Mildmay Liveable Neighbourhood summary of co-design engagement (Feb-April 2023)

About the Mildmay Liveable Neighbourhood project

Proposal 1.1 – Improvements on King Henry’s Walk

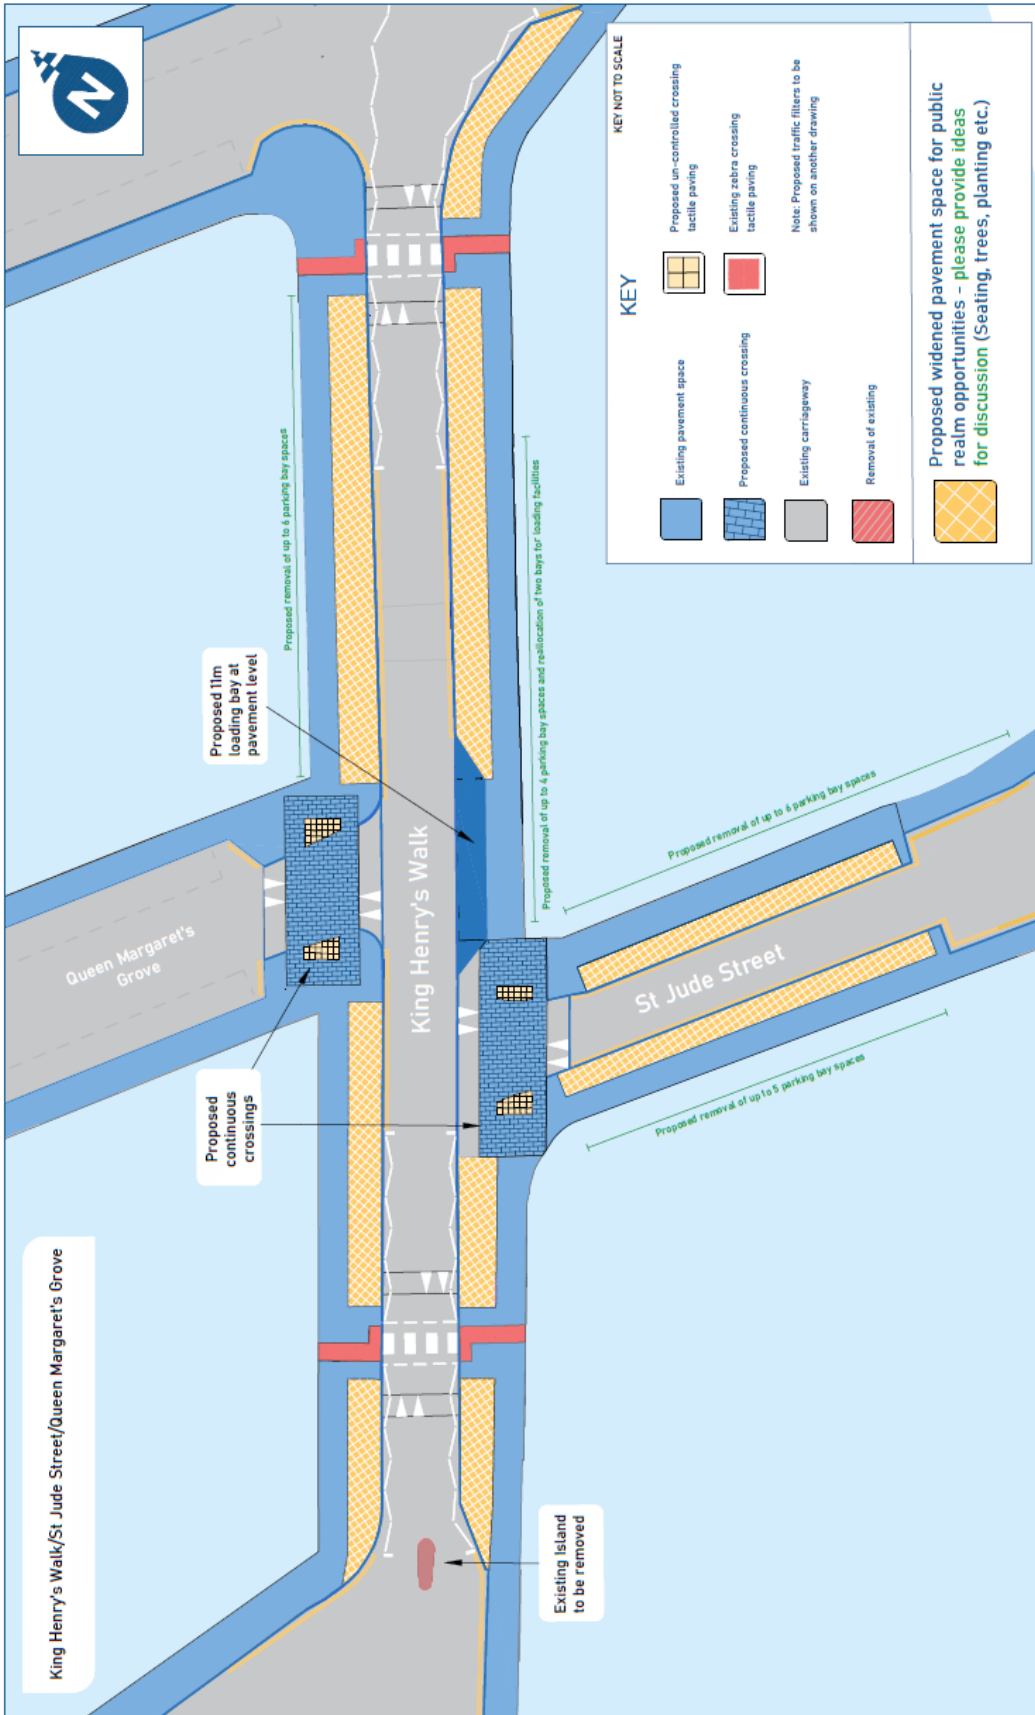
The top theme coded from the comments indicated general support for the proposals. Respondents also expressed support in their own words (unprompted) for specific themes such as street greening (including new trees), community spaces (including parklets seating/benches), and removal of on-street car parking in the area of this proposal.

More-negative-leaning themes coded from the comments included concern about removal of parking, concern the proposed scheme is unnecessary/waste of money, concerns about the necessity and cost of widening pavements, and concern that the proposals leave less road space for motor vehicles.

Additionally, some respondents indicated that better maintenance is needed in the area (for example re-surfacing roads, clearing litter, improving drainage, and fixing potholes).

Proposal 1.2 – Improvements at Mildmay Road / Mildmay Park junction

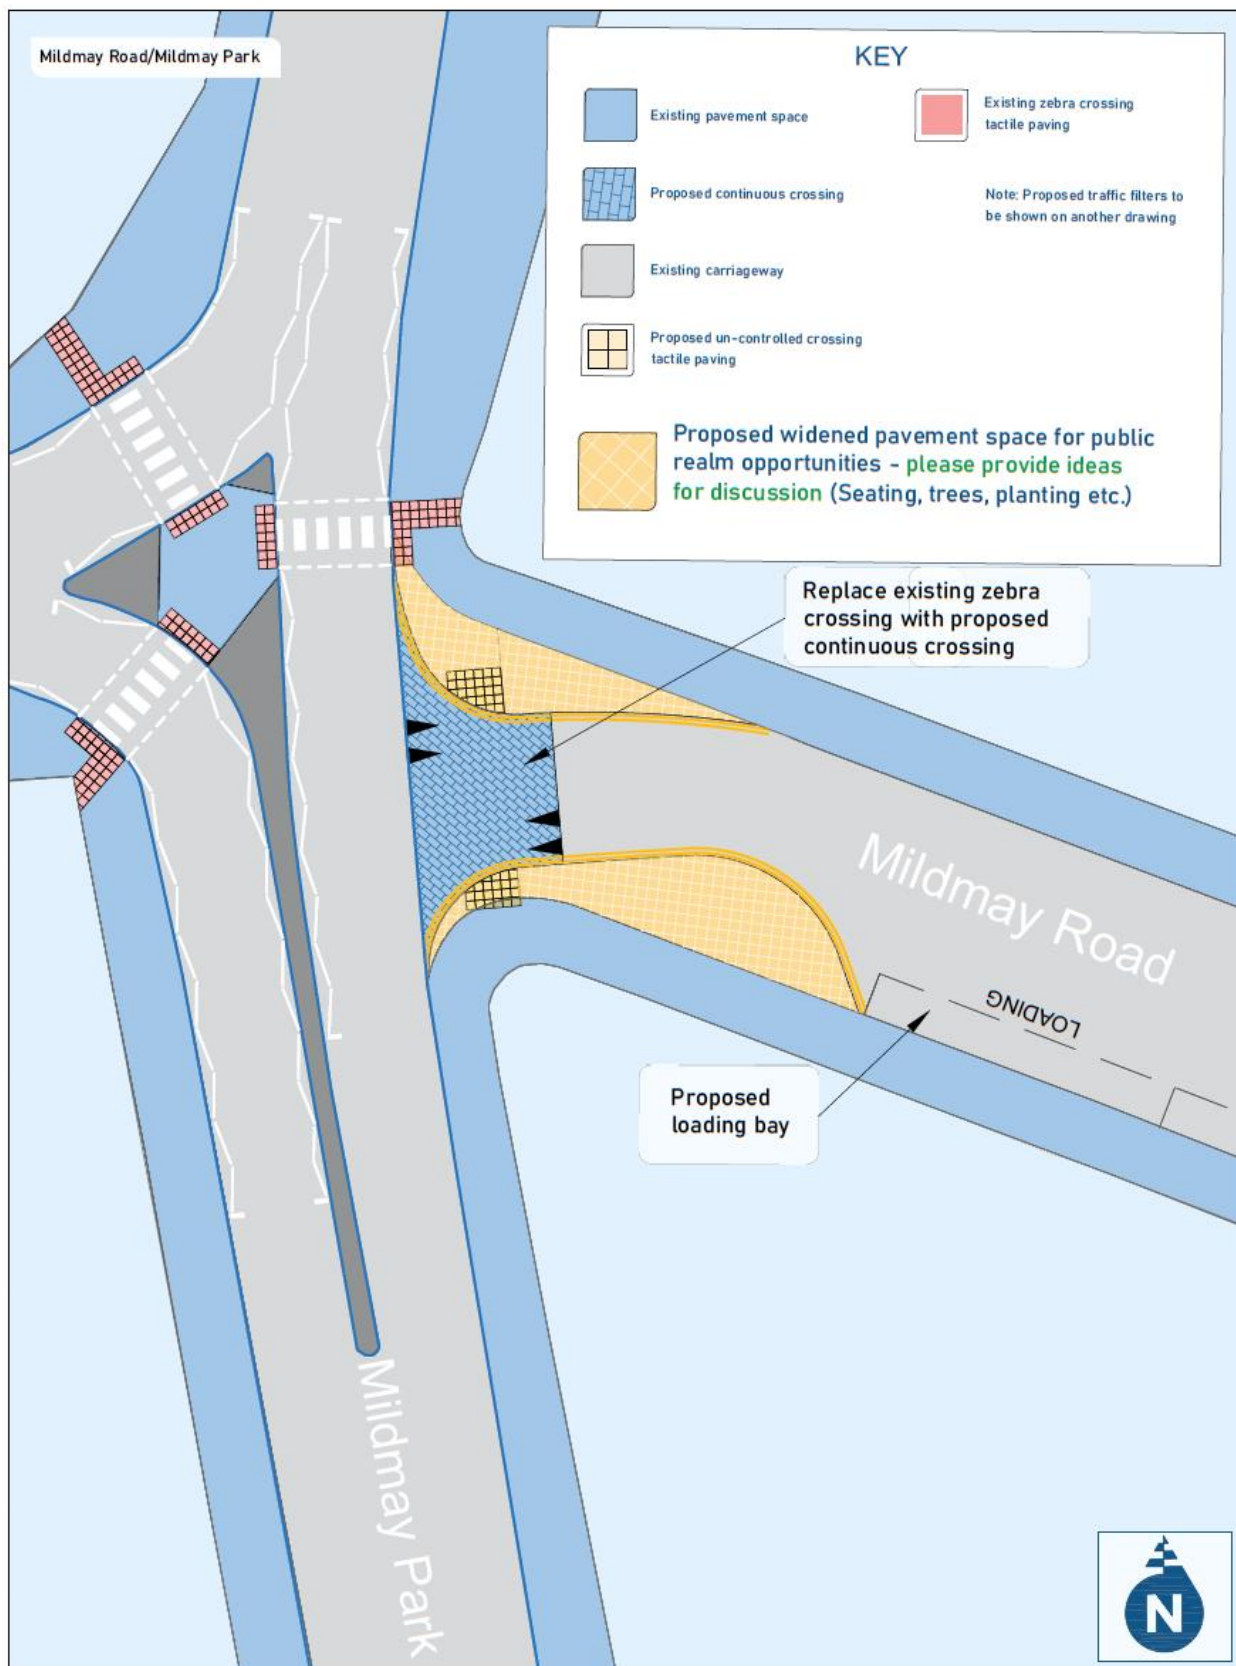
Respondents expressed support in their own words (unprompted) for improving the crossing and for wider pavements and new greenery, that the changes would benefit pedestrians, and that the current layout of the junction is unsafe for multiple road users. More negative-leaning themes coded from the comments included concern that changes to the crossing are unnecessary/waste of money.

Some respondents also indicated that the crossing should be integrated with improvements to cycling, such as allowing cyclists to safely travel west from Mildmay Road onto Newington Green.

Proposal 2.1 – Improvements around Newington Green Primary School

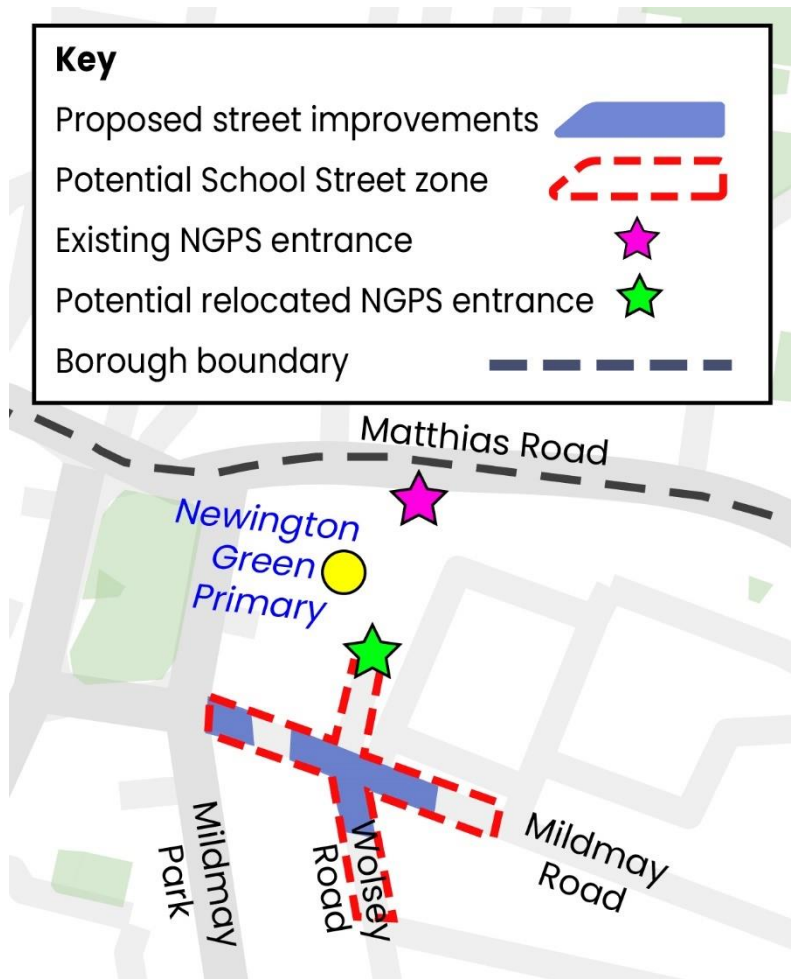
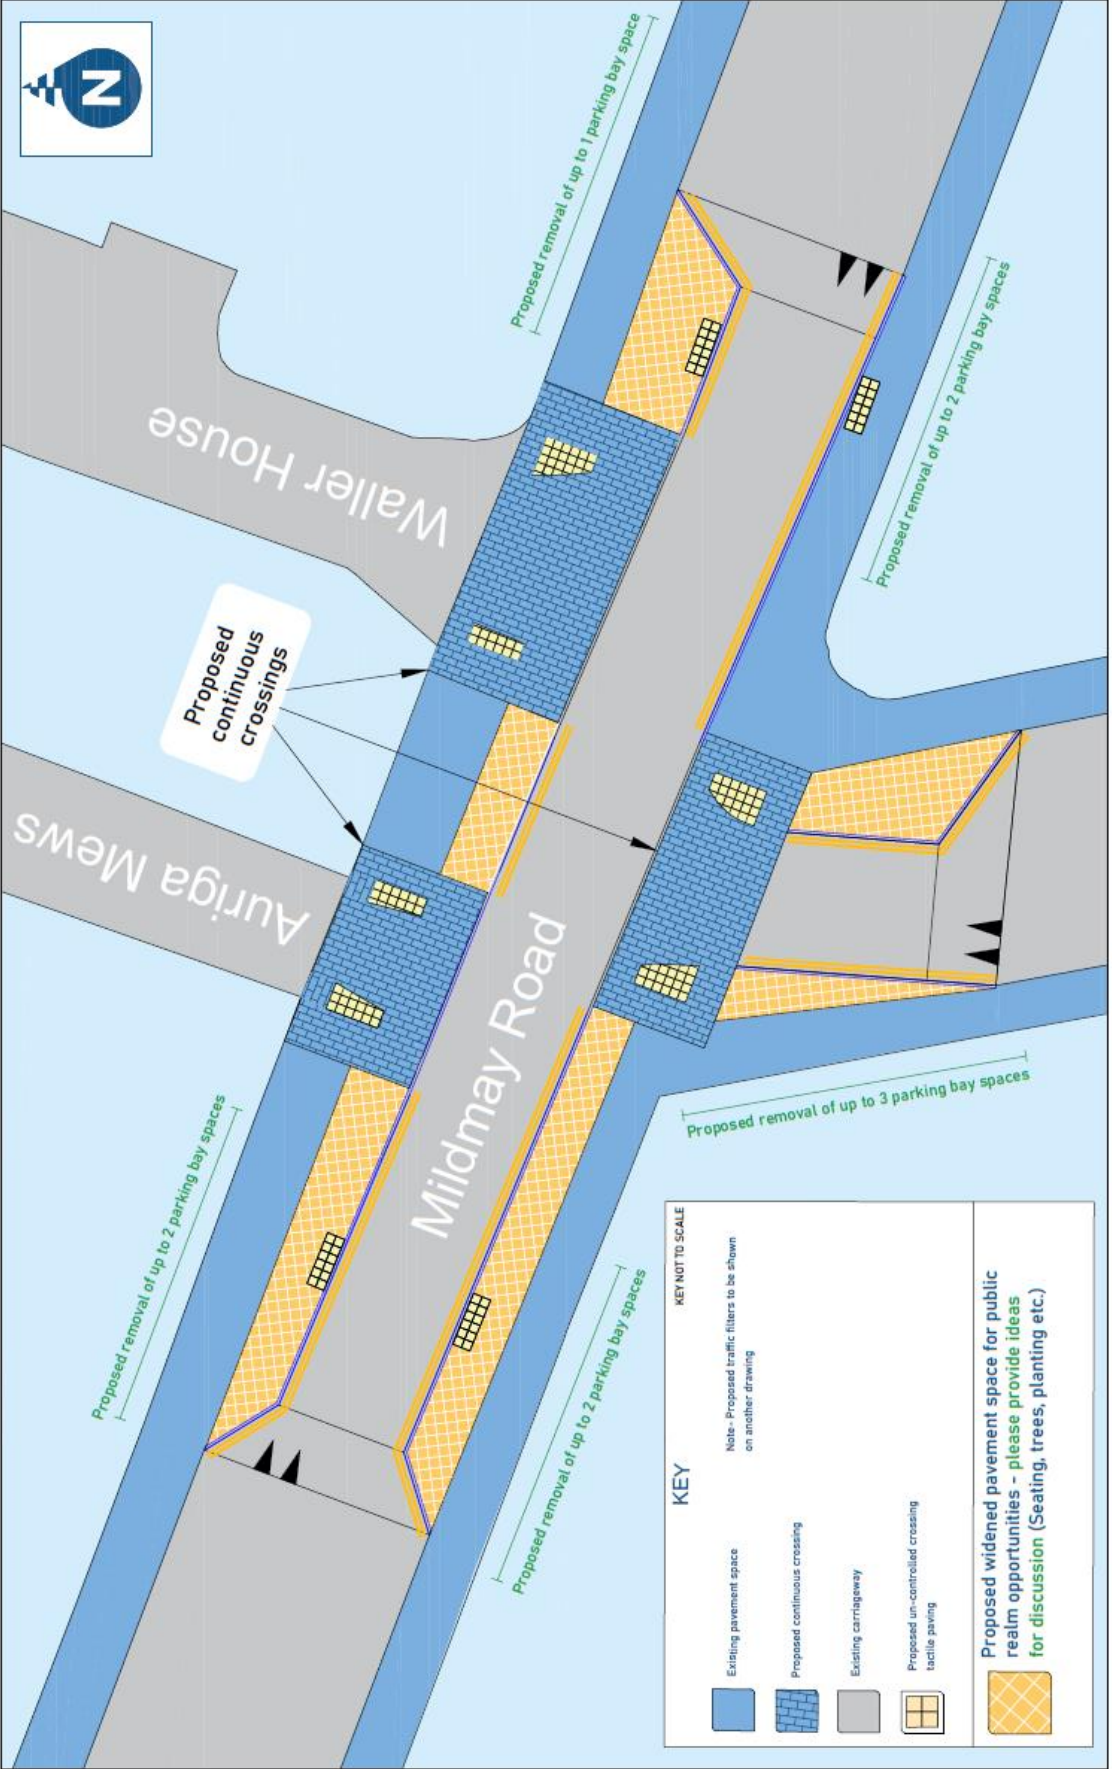
Some responses expressed general support for the proposals, and some explicitly expressed support (unprompted) for relocating the school entrance. Negatively-themed comments included concerns that the proposals may increase traffic congestion, that the scheme was unnecessary, and that the scheme would increase pollution. Most respondents who left negatively-themed comments said they owned or had access to a car.

Proposal 2.2 – Improvements around St Jude and St Paul’s Primary School and The Children’s House School

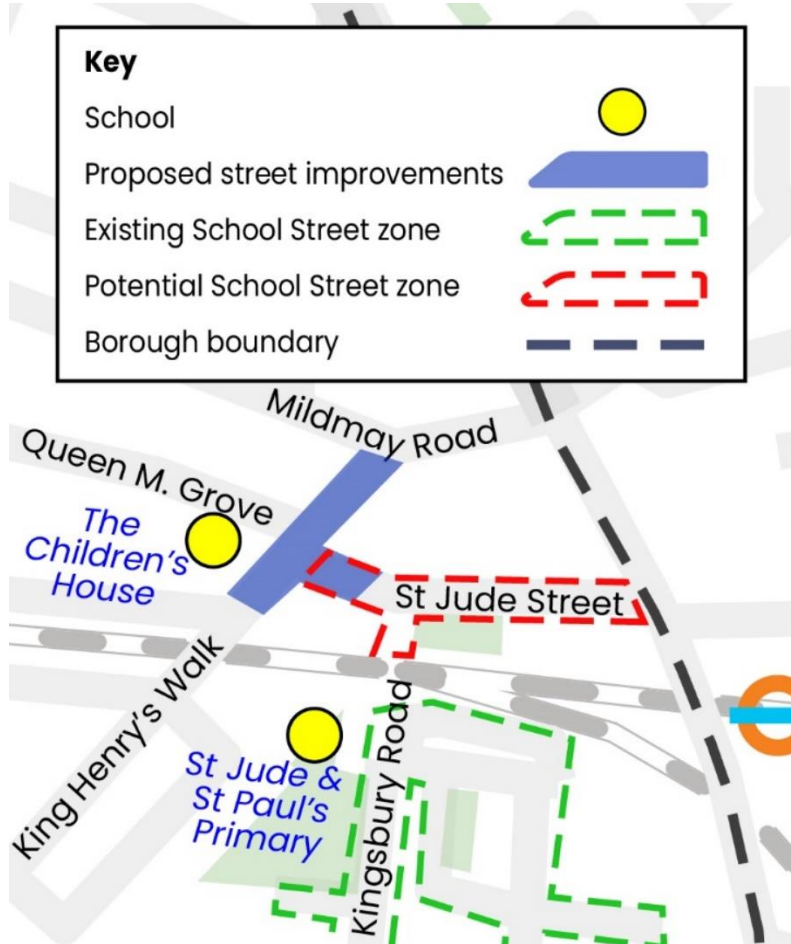
The responses showed that there was general support for the proposal. Some respondents also said in their own words (unprompted) that they supported the proposal because it would improve road safety.

Negatively-themed comments included that the scheme is unnecessary, that the scheme would increase traffic, that the scheme prioritises pedestrians and cyclists over other road users, and concern about residents accessing the area by motor vehicle. The majority of more negative-leaning themes coded from the comments were made by respondents who said they owned or had access to a car.
